Access Compliance Report

Public Rights-of-Way

(Curb Ramps)

Intersection ID: 50600	Main Street: BENDING_BRANCH_RD	Cross Street: HEARTLEAF_RD	Location: W
ADA ID: 569C53F5A289	Ramp Type: Perp	Initial Pass/Fail: Fail	Overall Compliance: No
Severity Score: 8.75			
Codes/Mitigation Info/Possible Solution		Field Measurements/Component Compliance

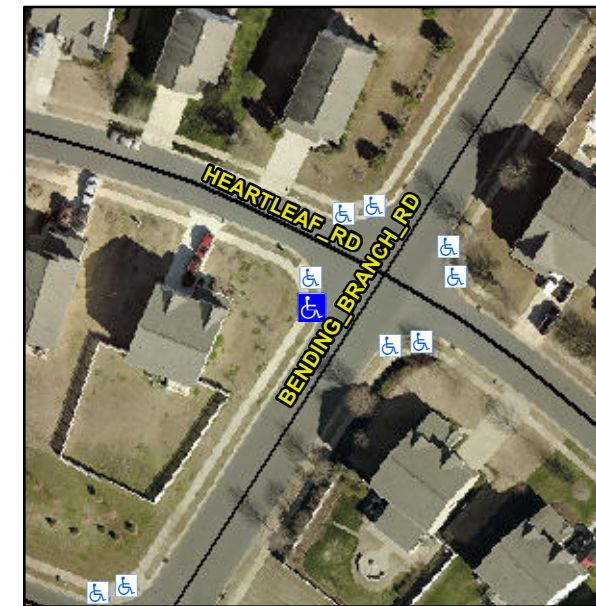
Not Found, R304.5.1

Compliance	Description	Data	Compliance	Description	Data
N/A	Ramp Length (in)	47.5	Yes	Ramp Slope (%)	6.6
No	Ramp Width (in)	46.0	Yes	Ramp XSlope (%)	0.7
N/A	Flare Type LT	N/A	N/A	Flare Type RT	N/A
N/A	Flare Slope LT (%)	N/A	N/A	Flare Slope RT (%)	N/A
N/A	Flare Traversable LT?	N/A	N/A	Flare Traversable RT?	N/A
N/A	Landing Length (in)	N/A	N/A	DWS Provided?	N/A
N/A	Landing Width (in)	N/A	N/A	DWS Contrast?	N/A
N/A	Landing Slope (%)	N/A	N/A	DWS Length (in)	N/A
N/A	Landing X Slope (%)	N/A	N/A	DWS Full Width?	N/A
N/A	Landing Curb? (Y/N)	N/A	N/A	DWS Offset (in)	N/A
N/A	Shared Landing?	N/A			
N/A	Gutter Ponding?	N/A	N/A	Gutter Slope (%)	N/A
N/A	Gutter Lip Ht (in)	N/A	N/A	Gutter X Slope (%)	N/A
N/A	Painted X Walk1?	No	N/A	Painted X Walk2?	N/A
	X Walk 1 Direction	To SE		X Walk 2 Direction	N/A
N/A	X Walk 1 Width (in)	N/A	N/A	X Walk 2 Width (in)	N/A
	X Walk 1 Slope (%)	1.5		X Walk 2 Slope (%)	N/A
	X Walk 1 X Slope (%)	2.2		X Walk 2 X Slope (%)	N/A

Remove & Replace Entire Ramp.
